Appendix 8

Upstream Fishway Construction Permit Applications

Condition Compliance Application for the Shawmut Hydroelectric Project (FERC No. 2322)
Upstream Fish Passage Facility

CONDITION COMPLIANCE APPLICATION

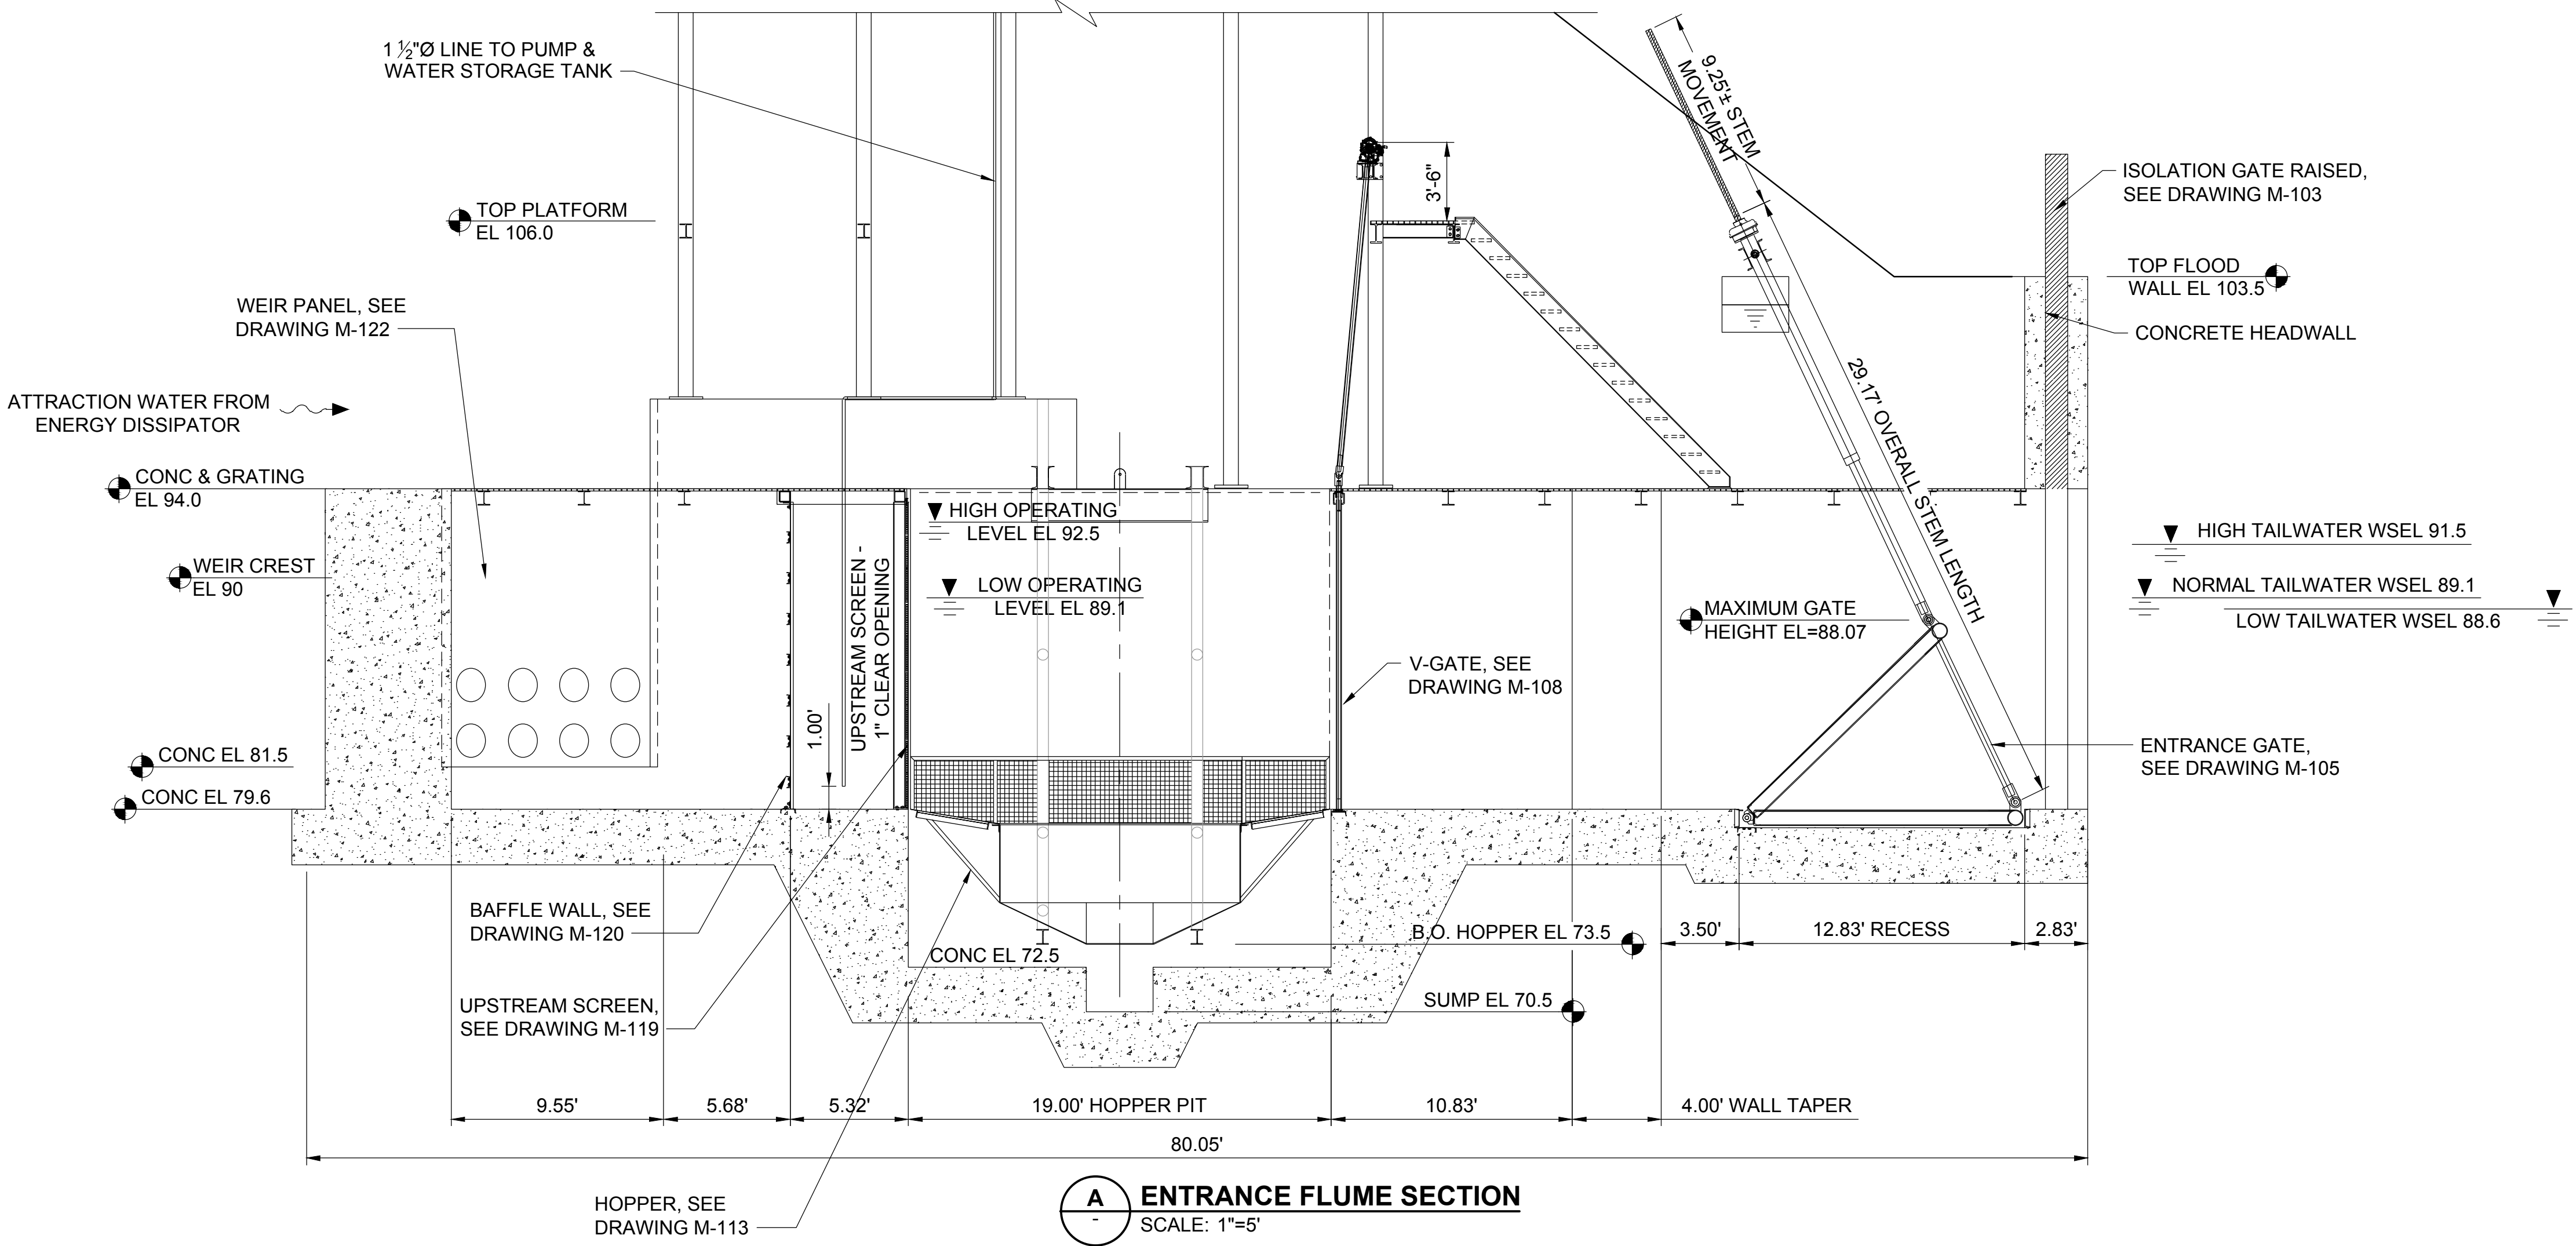
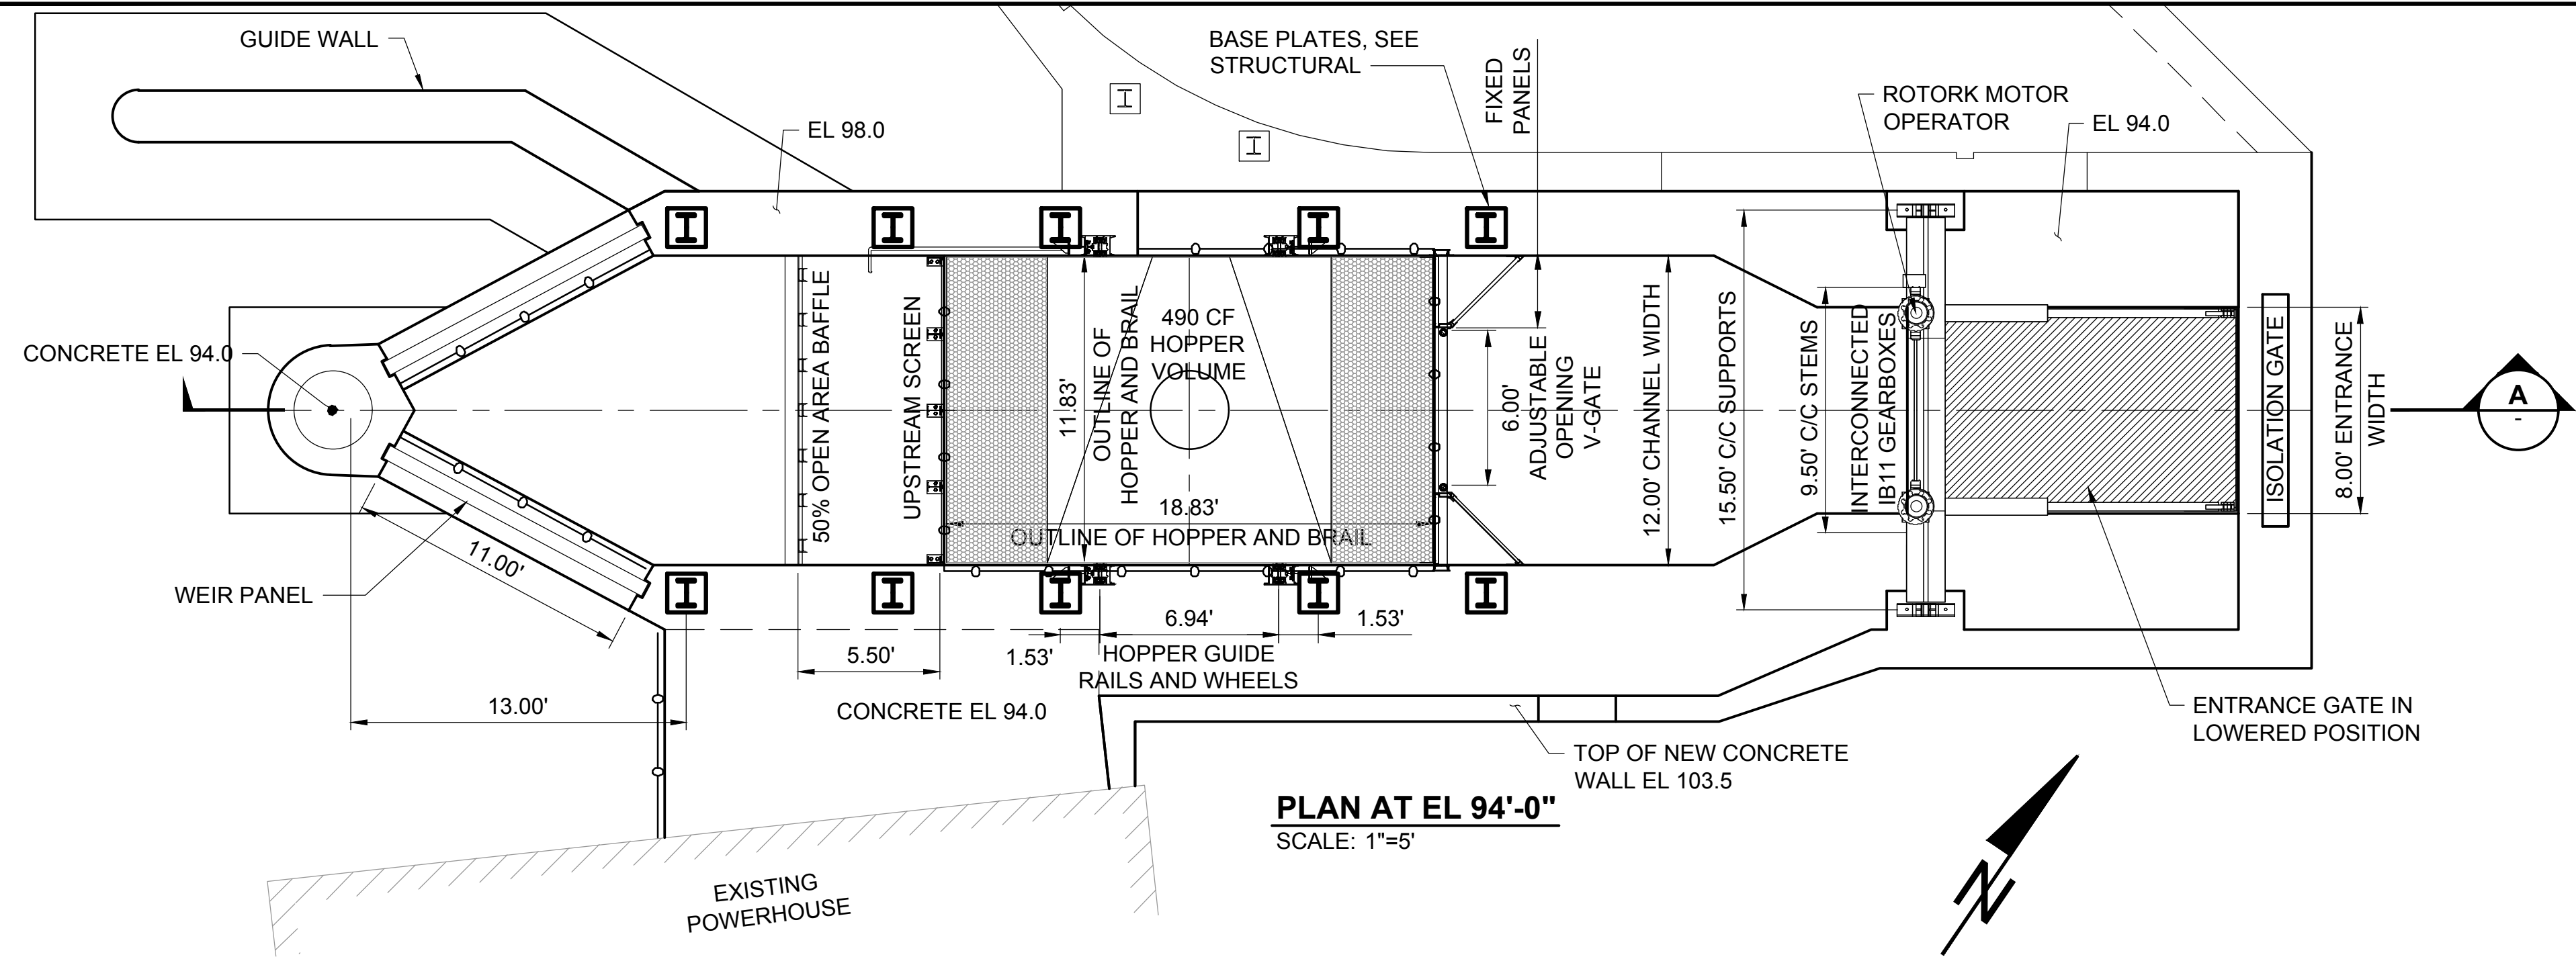
Sheet C-104: The dimension of the entrance width shows 10.0 ft. This dimension should be 8.0 ft.

4. DWG C-104 Note 1 - did not show depth

We also caught that one on Sheet C-104 and it has been corrected in our latest set issued for bid. See attached for reference.
